Attachment F: Supplementary Information in support of the Hunter Transmission Project Aviation Impact Assessment

Peer review (November 2025)

Warkworth Airfield risk assessment (May 2026)

Aviation Impact Assessment Peer Review

Figure 1: Indicative circuit pattern at Warkworth Aerodrome showing a one-nautical-mile final approach and the relative position of the HTP corridor

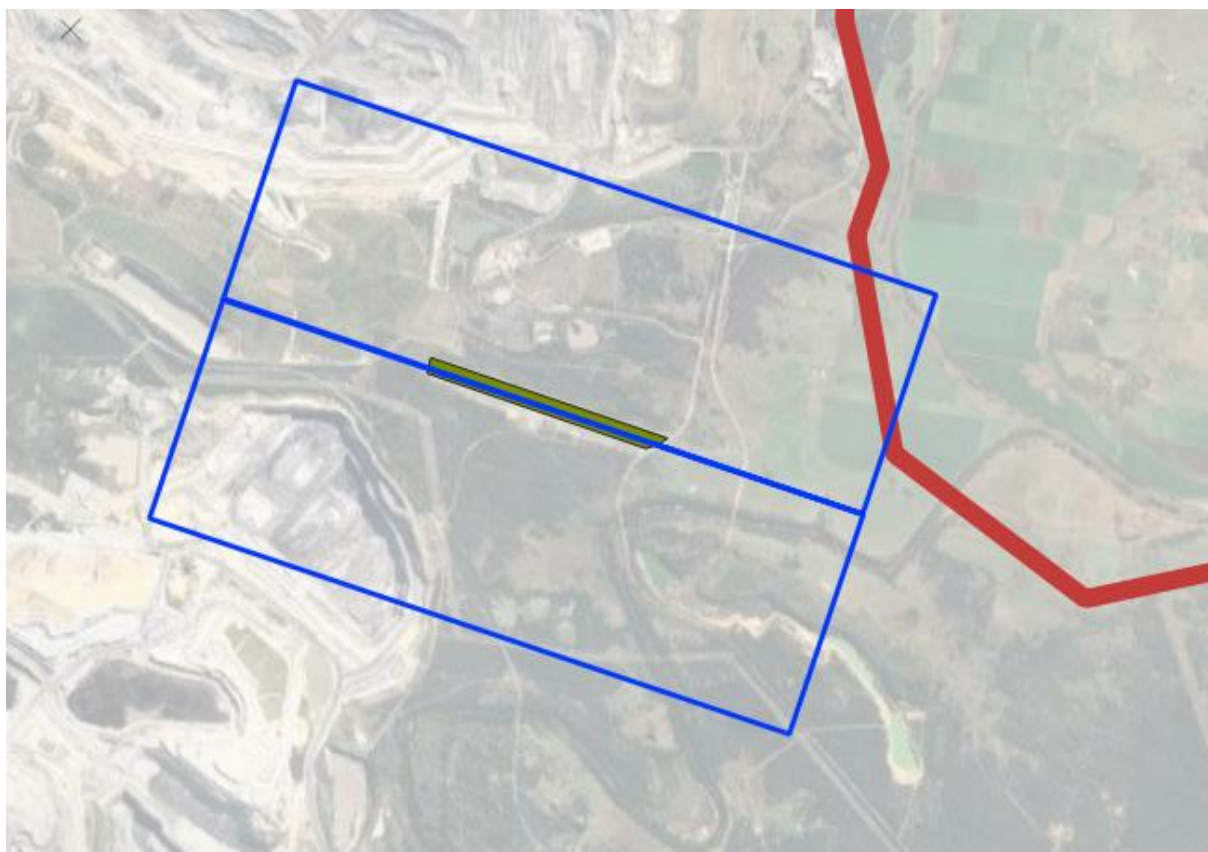
- **Circuit height variability (p. 31):** The AIA states that when joining the circuit from the east, aircraft would be at a minimum height of 1,000 ft above the runway when over the HTP corridor. This assumption requires clarification on how it was derived. Aircraft in the circuit typically turn on to their final approach at least 500 ft above aerodrome elevation (CASA AC 91-10 v1.6). If the 1,000 ft figure is based on specific data, such as flight tracking, consultation with the flight school, or other documented sources, the report should explicitly state this. Without clear attribution, the validity of this assumption remains uncertain.

A short assessment carried out by To70 below shows a typical circuit pattern based on a one-nautical-mile final approach, as determined by experience with other projects and analysis of publicly available flight tracks. While it is important to consider that circuits can vary significantly depending on aircraft performance, pilot decisions, and weather conditions, this shows that a base-to-final turn, the aircraft is descending, and may be conducted over and in proximity to the transmission line. Figure 1 illustrates a representative left-hand circuit pattern based on a one-nautical-mile approach, informed by To70's experience on comparable projects and review of publicly available flight tracks. As shown in the diagram below, a base-to-final turn may be conducted over, or in close proximity to, the transmission line alignment.

Figure 1 - Warkworth Aerodrome and proposed HTP corridor

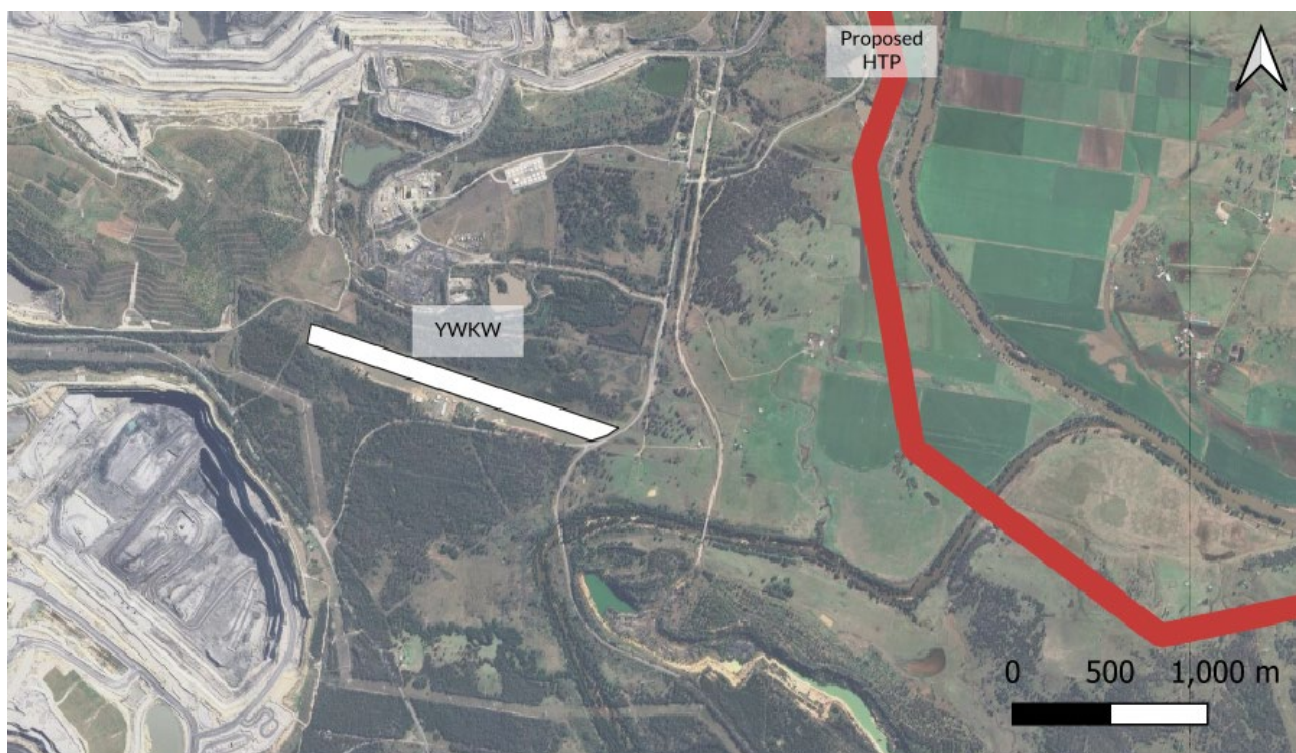
The HTP involves the construction of a 110 km overhead 500 kV transmission line between Bayswater and Olney. The planned corridor for the power line crosses approximately 1.4km of Warkworth Aerodrome's eastern boundary and crosses fields offering emergency landing areas for operations from the aerodrome.

The aerodrome location and proposed HTP corridor are illustrated in Figure 1 below. While the exact height of the HTP at every point is not yet available, the maximum height of the infrastructure (excluding construction) is estimated at 80m above ground level (AGL). A conservative estimation of 80m above airfield elevation has therefore been used for this risk analysis.

Figure 2 - Examples of aerotow departures from runway 10

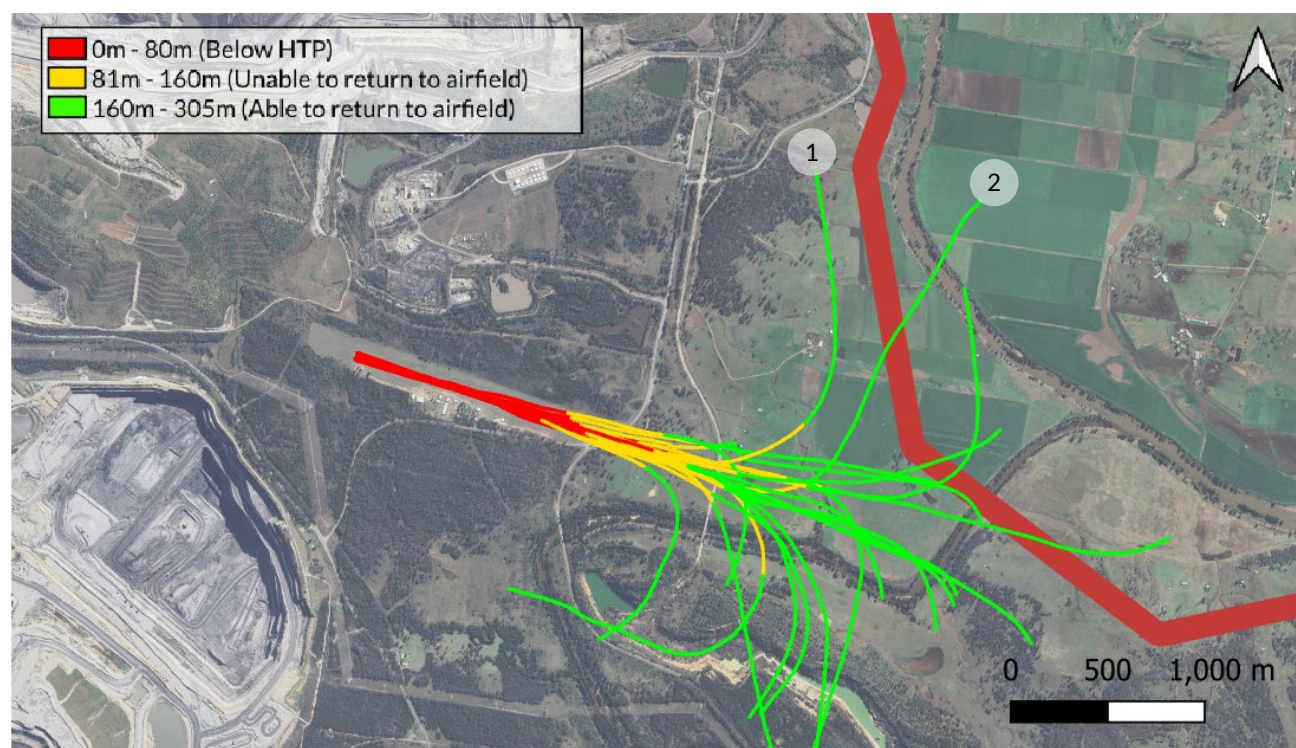
Figure 2 below shows a sample of 21 aerotow departures on runway 10 with the proposed HTP corridor overlaid. These flights were sourced from WeGlide.org³ and were collected from multiple days and limited to single-seat gliders with high wing loadings and two-seat gliders, which are likely to have shallower climb-out profiles.

Figure 2 shows that, based on this sample of flights, most flights would have sufficient altitude for the glider to make a safe return to the airfield following a launch failure in the vicinity of the HTP. However, for some flights (for example, those marked as 1 and 2), a launch failure during a short period may leave them in a situation where the safest landing option is in areas that could be obstructed by the HTP infrastructure. Due to poorer glide performance, a powered aircraft or towplane

would be less likely to have sufficient height to return to the airfield, and it would be more likely to conflict with the HTP infrastructure following an engine failure.
